247 (GLA/GLB) - Rearview Camera Noise Optimization

Topic number	LI54.71-P-080349
Version	5
Function group	54.71 - Camera and radar-assisted assistance systems
Date	6/2/26
Validity	247 (GLA & GLB) with all of the following: - Model Year 2024 and later (Option code 804, 805, 806, etc...) - Option code 459 or 485 (Steel spring variants)
Reason for change	Language updates.

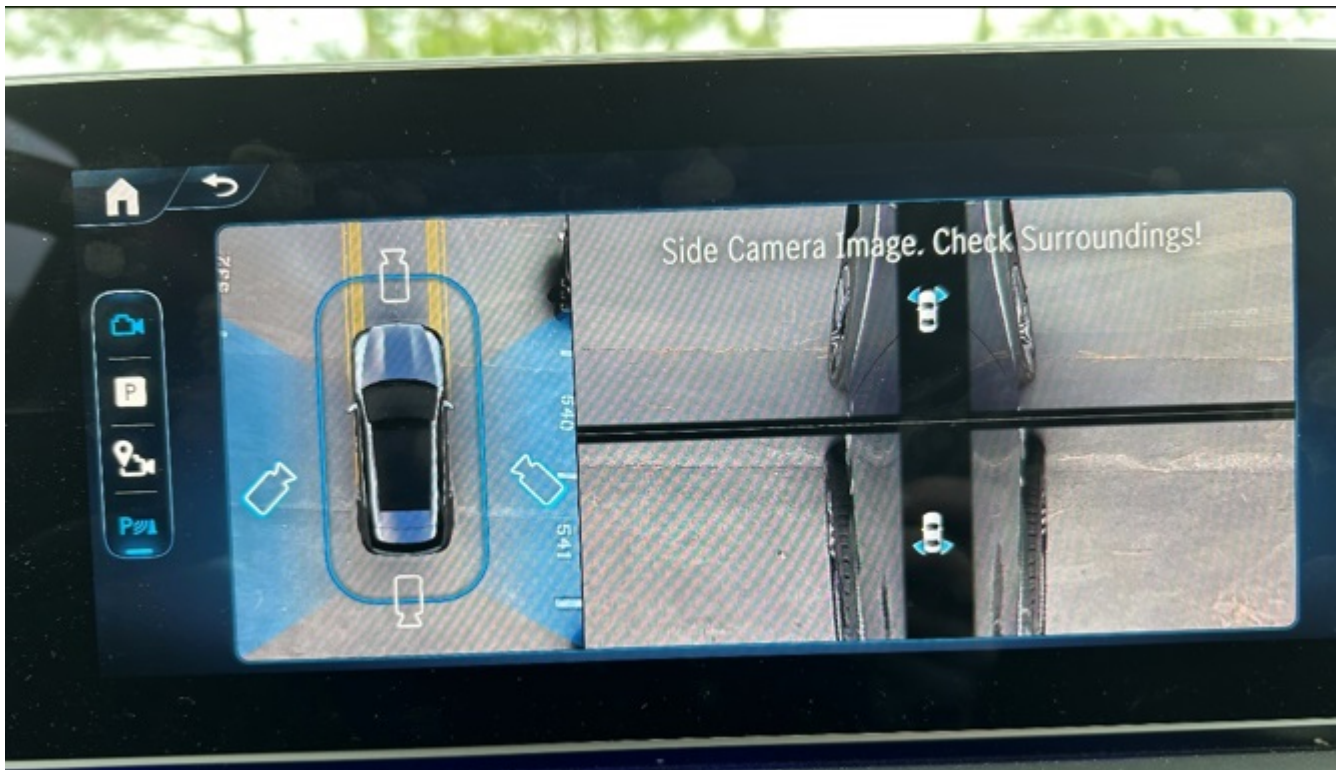
After both control units have been SCN coded, the "Movable 3D View" feature in the head unit will no longer be available. With this change there will be two distinct differences:

- 1) The "3D" icon when in the top down vehicle view, will no longer be present on the head unit.
- 2) The digital rendering of the vehicle with the ability to spatially move around the vehicle is no longer possible. This view is replaced with 2D static images of the left and right sides.
